A STUDY IN TEAK

DOORS — MADE IN VENEER

Same design · Planted mouldings · Construction only

AST-DR-015

SECTION ACROSS A PANEL · 1:2 · EVERY MEMBER PLANTED ON

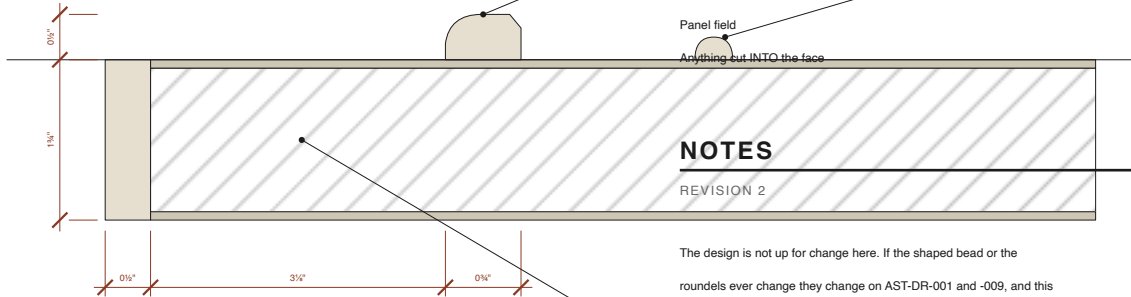
Panel field

was: sunk 13.5 into the solid
now: stays FLAT — the ovolo round it does the work
Ovolo sticking

was: worked on the stile edge
now: run as a separate 20 x 12 moulding, mitred on
Shaped bead

was: carved into the panel face
now: bandsawn to the curve in 10 x 6, planted on
Corner roundels

was: carved bosses
now: turned discs Ø26 x 5, glued on
The leaf

was: solid teak, 45
now: 38 blockboard, 12 lipping, veneer both sides

BLOCKBOARD CORE
Lipping is solid teak on all four edges so the leaf can be trimmed on site and the hinges and lock screw into wood, not into board.

Veneer both faces of the core and balance it: same thickness back and front, or the leaf will bow.

Ovolo, bead and bosses in solid teak, polished to match. They are small enough to take solid without moving, and they give a crisper arris than a cut face would.

Set the bead out from the panel opening, not from the leaf edge, so the four roundels land exactly on the corners of the curve.

OPEN — glue and pin, or glue only? Pins need filling and the filler shows through polish. Glue and cramp if the shop can.
